St. Johns County Board of County Commissioners

ADDENDUM #2

To: Prospective Bidders
From: St. Johns County Purchasing Department
Subject: BID NO.: 19-83 Northwest WTP Phase 1 (6 to 9 MGD) Expansion

- 19-83 Bid Form Rev 082119
- Section 312223 Ground Improvement Systems
- Section 260150 Electric Motors
- Section 400562 Plug Valves
- NW Well #1 and Well #2 Location Map

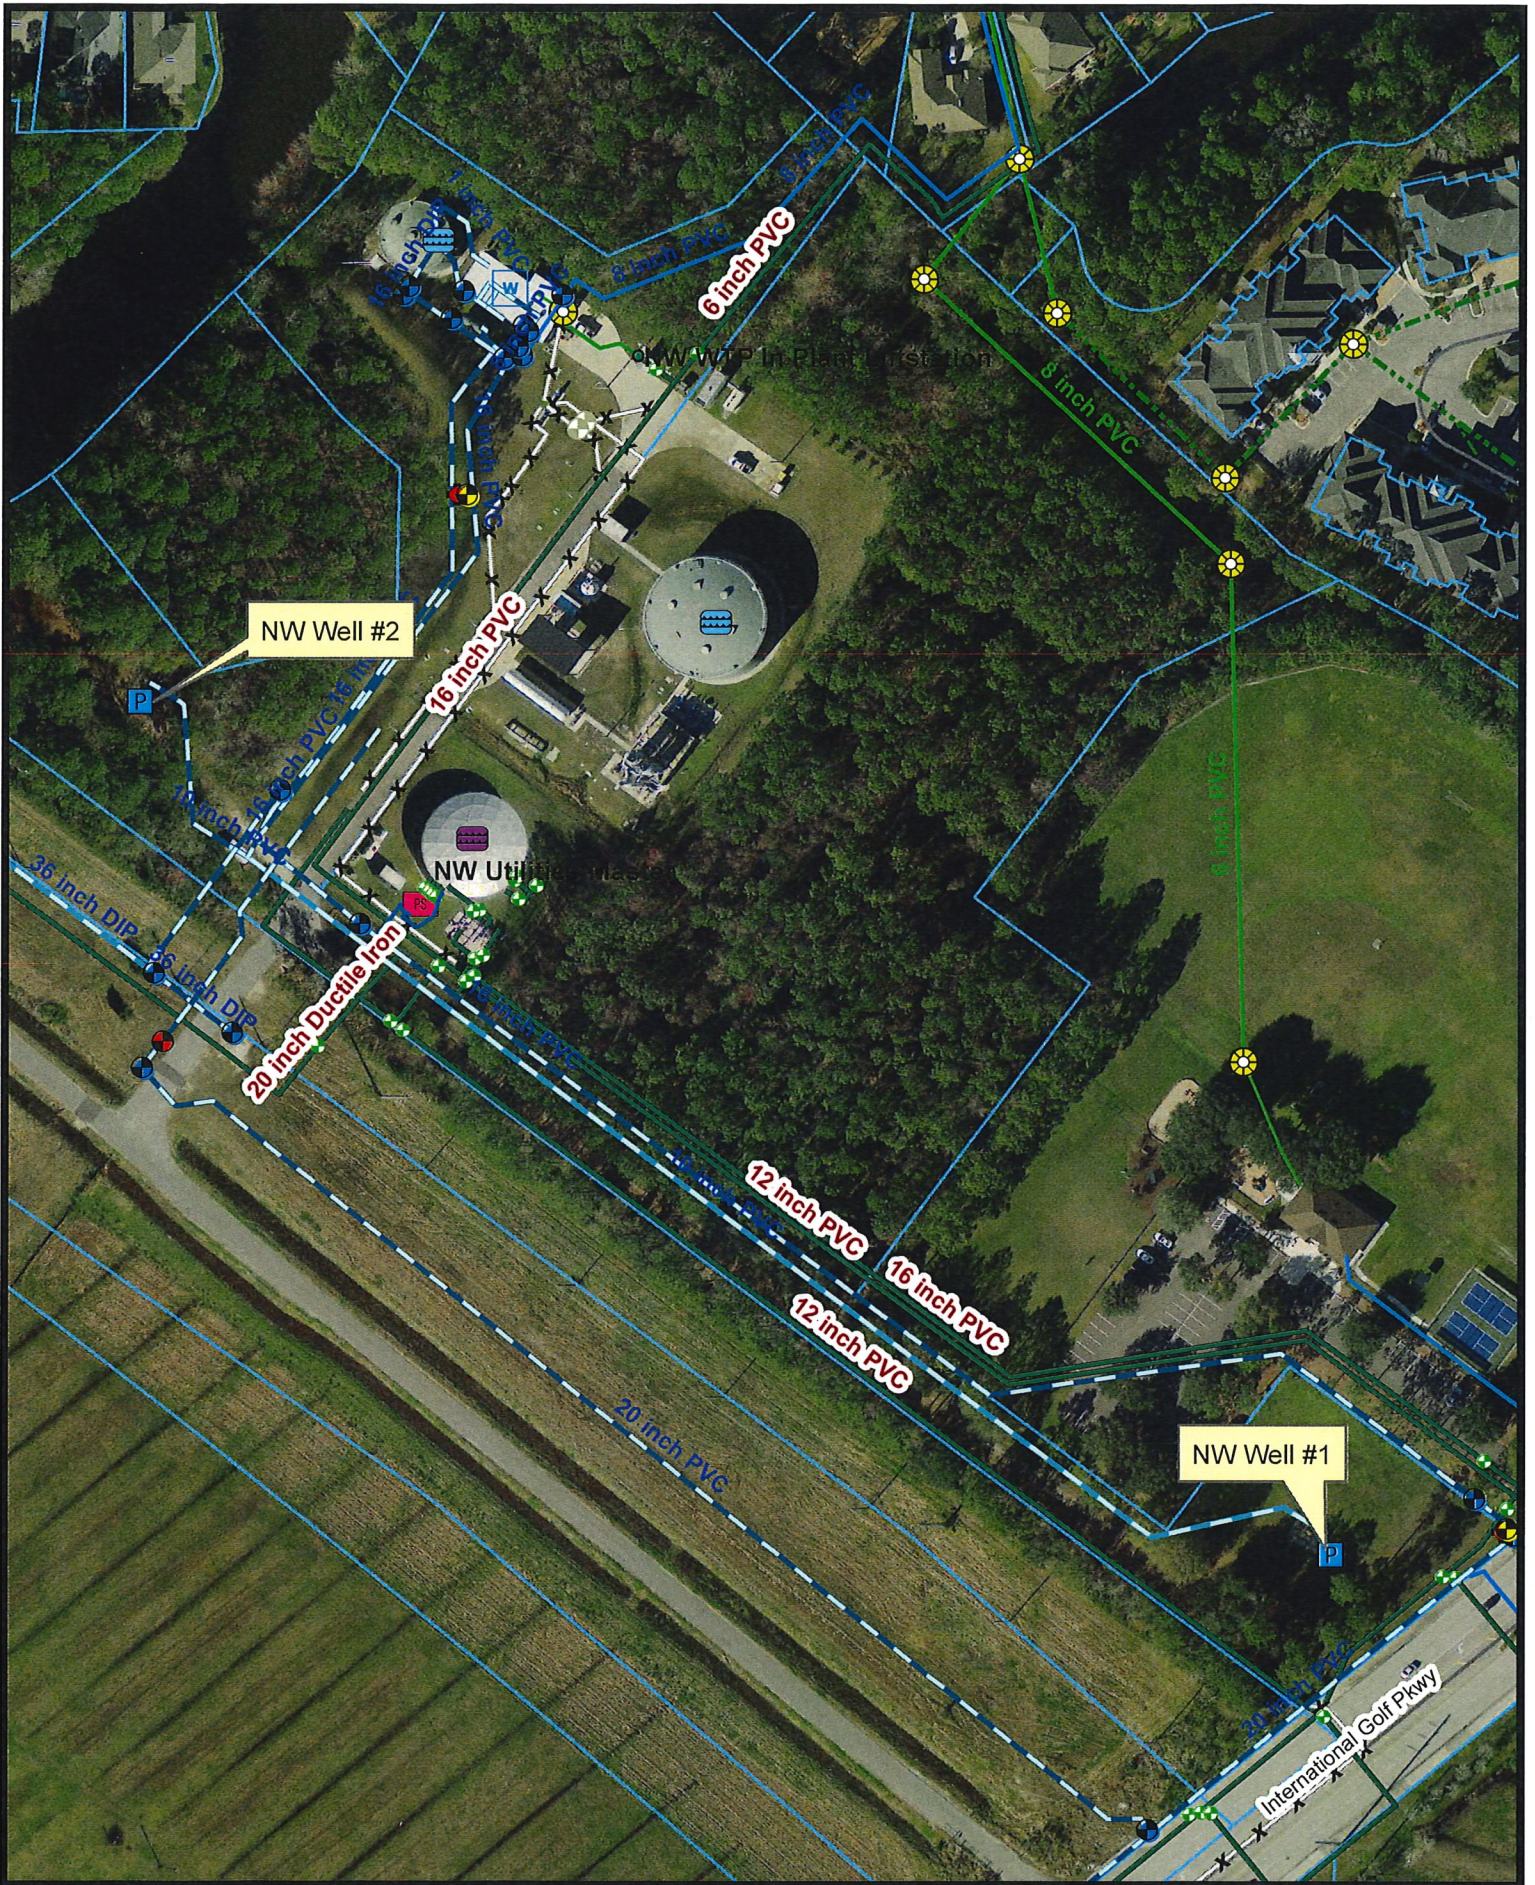
50. DWG E9 Note 9: Locate Well #1 and Well #2. Neither well is shown on any drawings.

Please refer to the attached scaled map that shows the locations of Well #1 and Well #2.
